M-1.0t MAGNETIC FIELD POWER AMPLIFIER SERVICE MANUAL

**CARVER CORPORATION
SERVICE BULLETIN**

Service Bulletin # M-1.0t-2	Model M-1.0t	Serial # as needed
-----------------------------	--------------	--------------------

Service Bulletin # M-1.0t-3

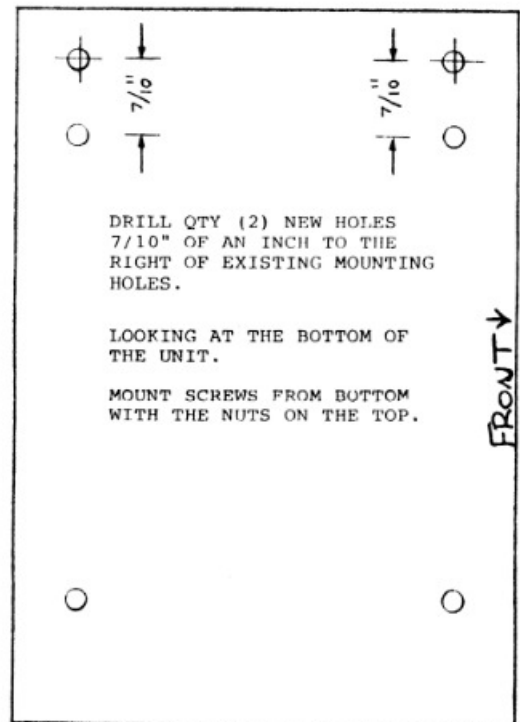
Reason: New Power Transformer being used.

Procedure: When replacing the Power Transformer in the M-1.0t from the original type to the current type, two new mounting holes must be drilled into the bottom sub-panel.

The new Transformer is also wired differently, with the correct connections listed below by terminal number

Delete: Qty (1) NPT-2154 Transformer

Add: Qty (1) 617-10033-01 Transformer
 Qty (4) 151-20152-00
 10-32 X 3/8 Phillips Screw
 Qty (4) 152-10004-00
 10-32 Kepnut

11	ORANGE	TO P402-4
WHITE FROM	13		
THERMAL SWITCH	12	10	RED TO P401-3
	9	BROWN	TO P402-2
BLACK TO TAP-2	4	8	BLACK TO P401-1
BLACK TO TAP-1	3	7	BROWN TO P402-1
ORANGE-SUPPLY	2	6	RED TO P401-2
BLACK-SUPPLY	1	5	ORANGE TO P402-3

INCORRECT POSITIONING OF TRANSFORMER

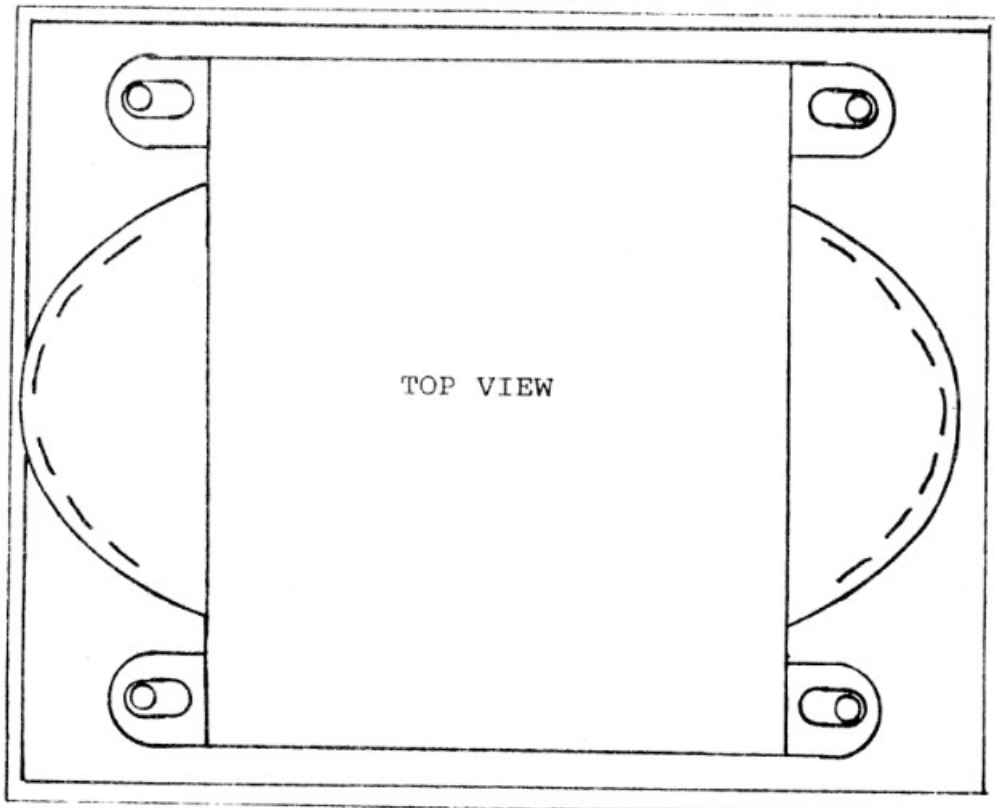
Reason: Power Transformer Primary wires have the potential to short out against the chassis due to the mounting location of the transformer.

- Procedure:
1. Remove screws that hold top cover; remove cover.
 2. Check clearance between the transformer windings and the chassis. This clearance must equal or exceed .050 inches.
 3. If clearance is less than that required, remove the two left mounting screws and relocate the transformer and position to center of mounting plate.
 4. Drill two new mounting holes using the transformer mounting lugs as a guide.
 5. Check for any loose metal shavings; Mount two screws.

FRONT OF UNIT
CORRECT POSITION OF TRANSFORMER

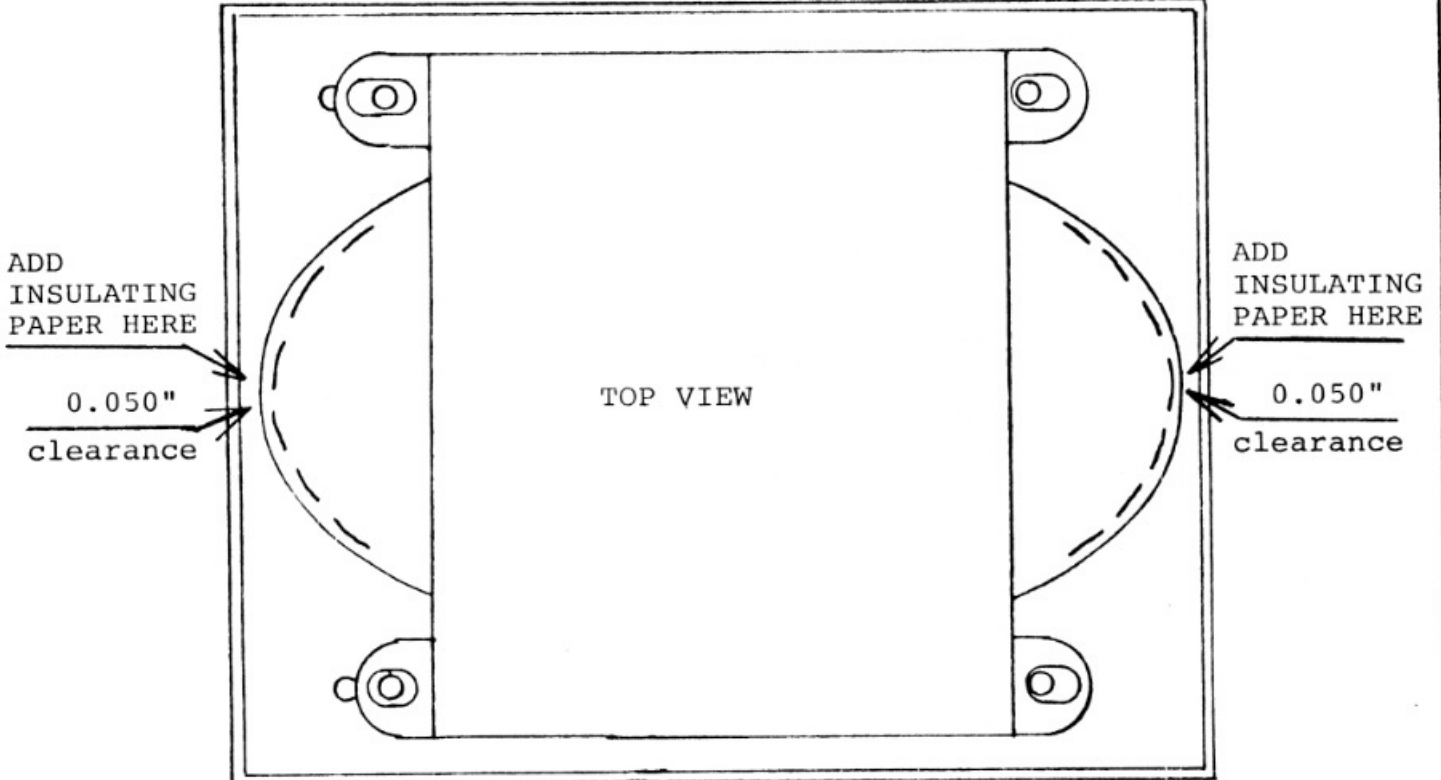
Reason: SEE PAGE ONE.

- Procedure: 6. Install (2-1/2)" x (1-1/2)" Insulating paper (108-00102-00) with a 90 degree bend 3/4" from the end of the (2-1/2)" dimension in the left bottom corner of the Transformer mounting pan. The paper is secured on the bottom side with a SMALL amount of RTV (epoxy). This paper is to be used on BOTH SIDES if the clearance on the right side of the transformer is less than .050 inches. SEE BELOW
7. Hi-Pot all units at 1250v.
8. Function test any units that have had new mounting holes.

POSSIBLE POSITION OF NEW HOLES

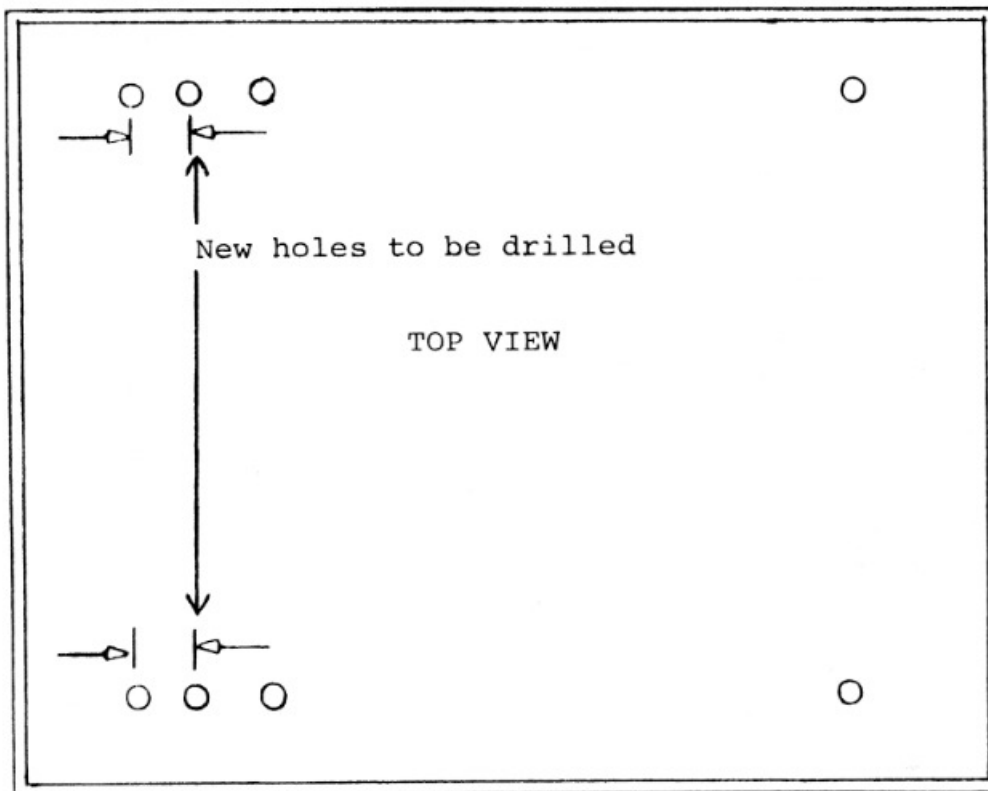
Reason: SEE PAGE ONE.

- Procedure: 8. (continued) The function test required is limited to powering the unit up and driving both channels with a signal generator. Check for proper LED movement.
9. Reinstall top cover.
10. FOR WARRANTY CLAIMS AND VERIFICATION REMOVE SERIAL NUMBER AND ADD NEW SERIAL NUMBER LABEL. (OBTAINED FROM SERVICE DEPARTMENT).
SEND IN OLD SERIAL NUMBER WITH WARRANTY CLAIM, THIS MUST BE DONE OR CLAIM WILL NOT BE PROCESSED.

Service Bulletin # M-1.0t-5

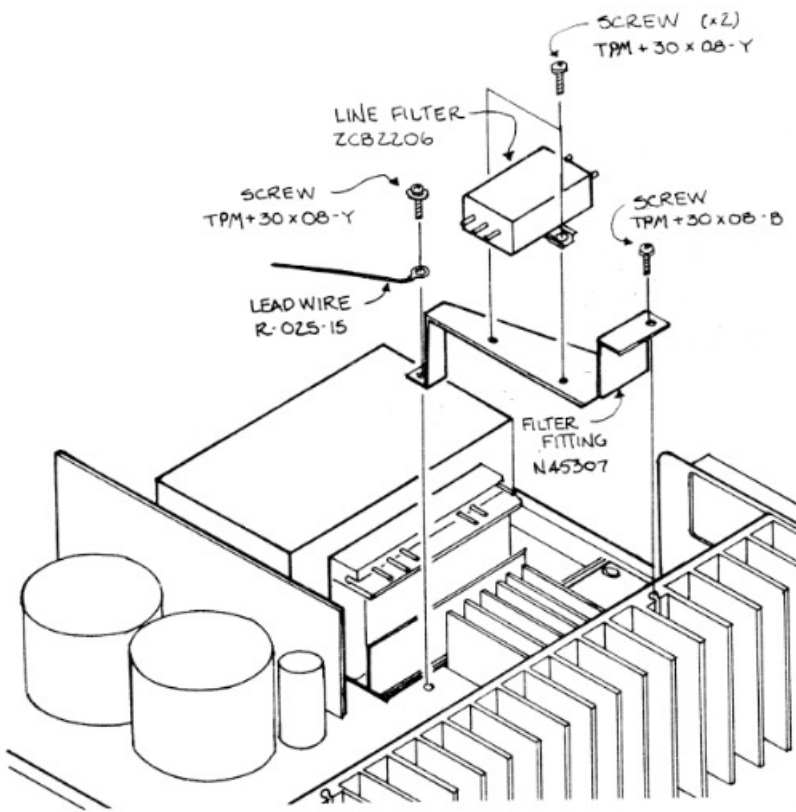
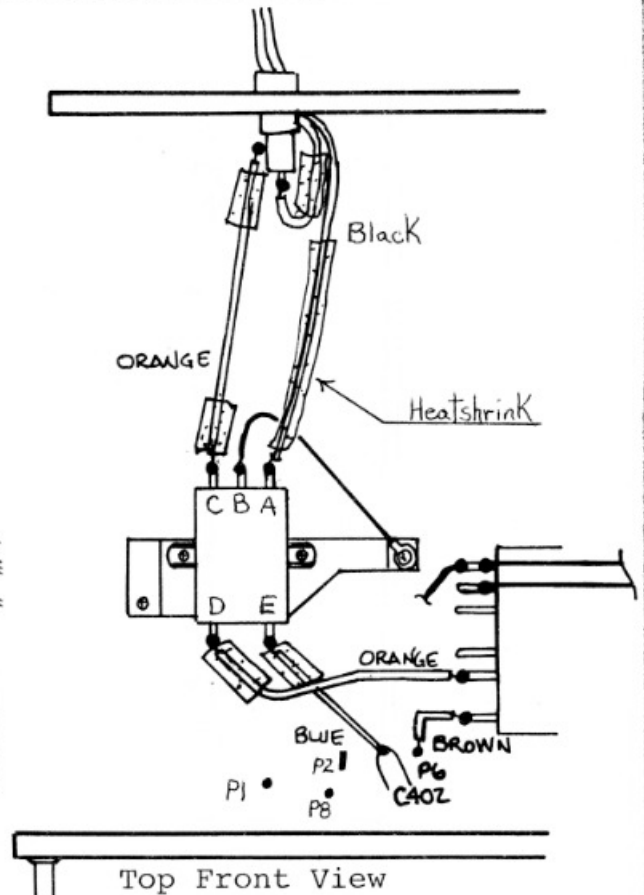
Reason: A.M. interference when amplifier is on.

Procedure: Remove C401, C402, C403 from power supply board.

Remove black wire from P2, cut off 4", solder to tab "A".

Remove orange wire from P8, solder to tab "C".

Remove orange wire from P1, solder to tab "D".

Add blue wire from tab "E" to hole where C402 was closest to C404.

Add black ground wire from tab "B" to ground of chassis.

NOTE: Add heatshrink tubing on wires to filter.

Fig. 1.

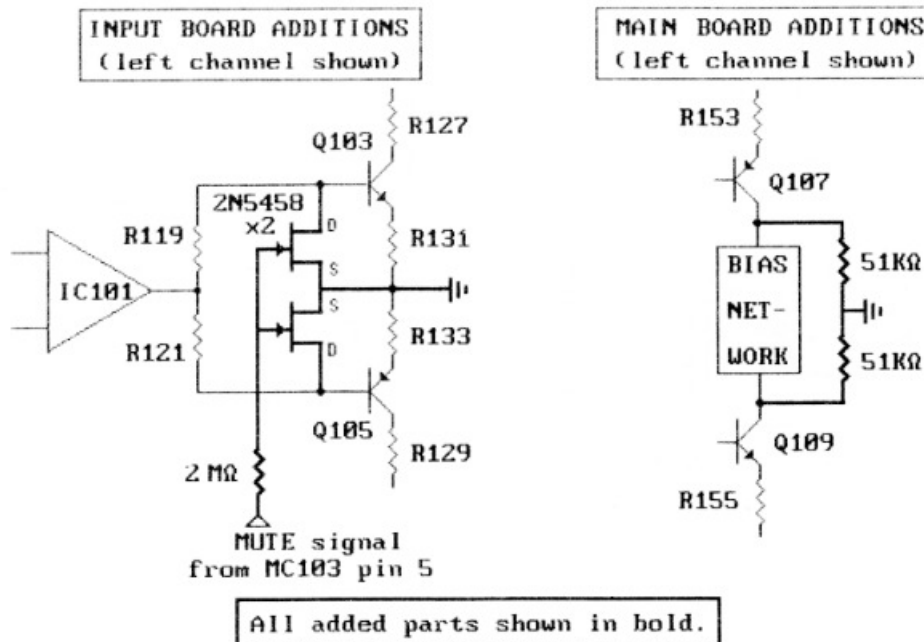
Service Bulletin # M-1.0t-6A	Model M-1.0t	Ser.# As Needed
Problem: Turn on / turn off thump.		Date 11/01/89

Note: Turn-off thump in excess of 2 volts p-p may indicate unbalanced $\pm 12V$ supplies, leaky input op amp IC101, or shorted commutator transistor. Check these components before proceeding.

1. Remove input board and install FET's and 2 M Ω resistors as indicated in Fig. 2 and 3. All components must be installed on the foil side of the board. Re-install board.
2. Install 51 K Ω resistors on the foil side of the main board as indicated in Fig. 4 and 5.
3. Power up amplifier and test performance. Turn-off thumps should be less than 200 mV into 8 Ω dummy loads. May be monitored on DC coupled scope set to slowest sweep setting.
